1994 Corvette: Service Bulletin: Garage Shift Delay Engagement (New Garage Shift Package)

Bulletin Number: 47-71-20A

REVISION: 09/12/94

ORIGINAL GARAGE SHIFT PACKAGE

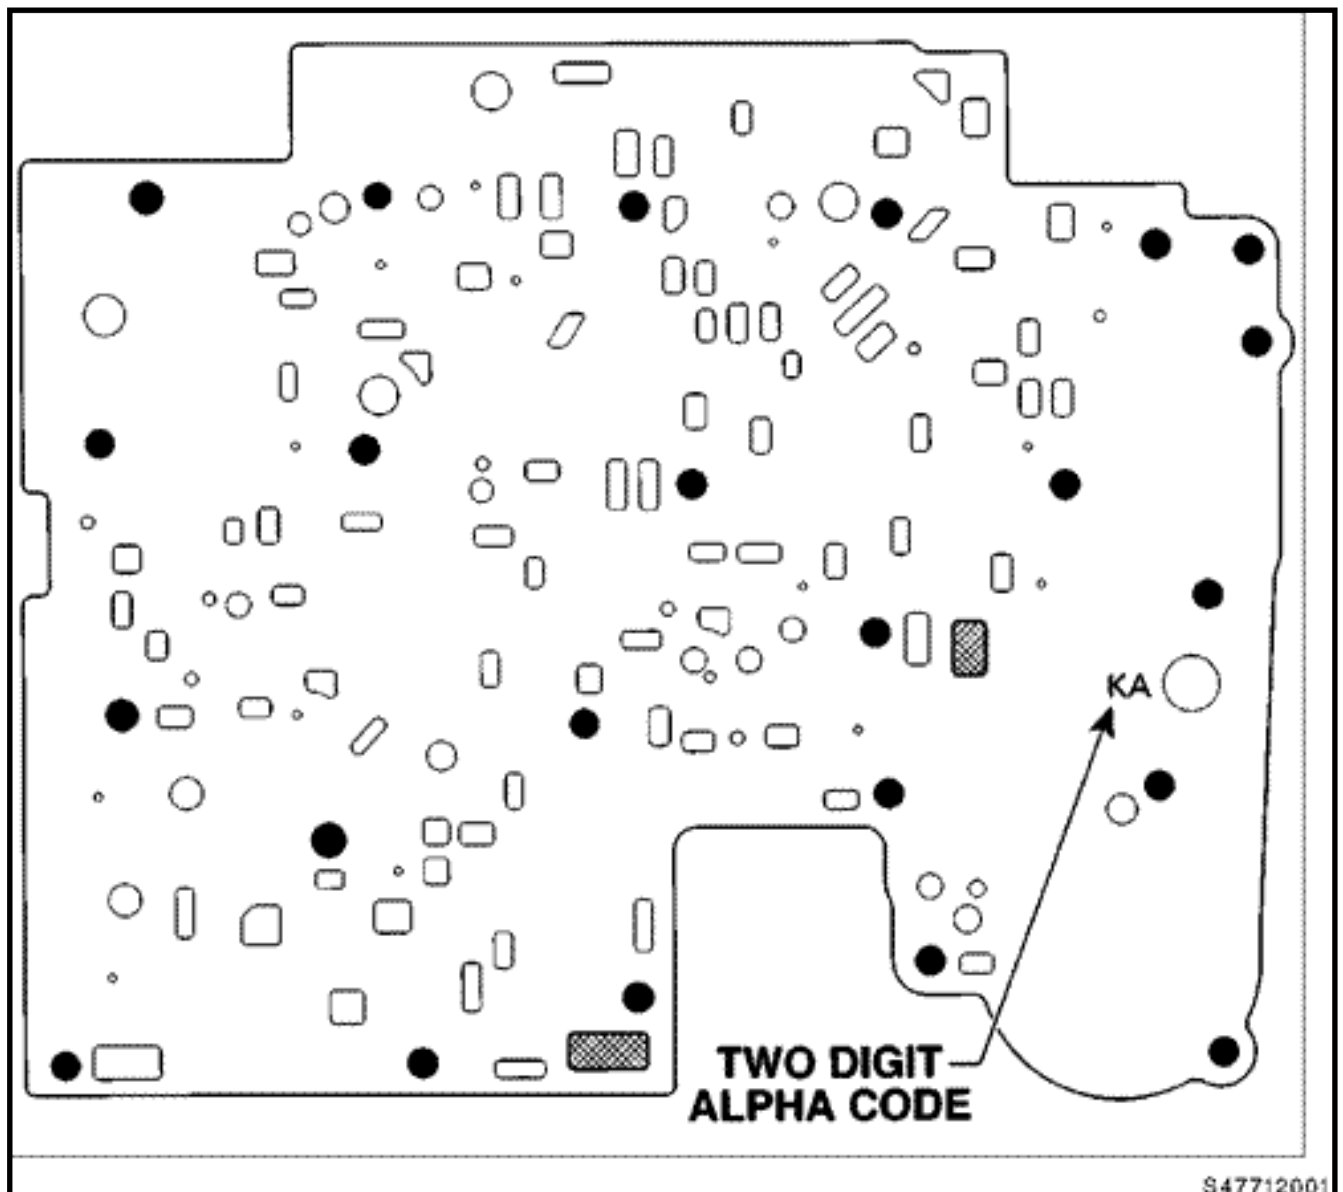
WHEN PERFORMING ANY OTHER REPAIRS ON A 1994 VEHICLE EQUIPPED WITH A HYDRA-MATIC 4L60-E TRANSMISSION BUILT BEFORE MARCH 7, 1994 (JULIAN DATE 066), THE SPACER PLATE IDENTIFICATION MUST BE

CHECKED TO SEE IF THE TRANSMISSION HAS HAD A NEW GARAGE SHIFT PACKAGE INSTALLED TO BE SURE THE TRANSMISSION IS BEING SERVICED WITH THE PROPER PARTS. SEE THE FOLLOWING CHART FOR SPACER PLATE IDENTIFICATION.

THE NEW SPACER PLATES MUST BE USED WITH THE ENHANCED GARAGE SHIFT PACKAGE AND THE ORIGINAL SPACER PLATES MUST BE USED WITH THE ORIGINAL GARAGE SHIFT PACKAGE. THE SPACER PLATES AND GARAGE SHIFT PACKAGES ARE CALIBRATION SENSITIVE; MIXING SPACER PLATES AND GARAGE SHIFT PACKAGES MAY CAUSE PREMATURE FAILURE. WHEN A GARAGE SHIFT PACKAGE IS CHANGED, THE SPACER PLATE MUST ALSO BE CHANGED.
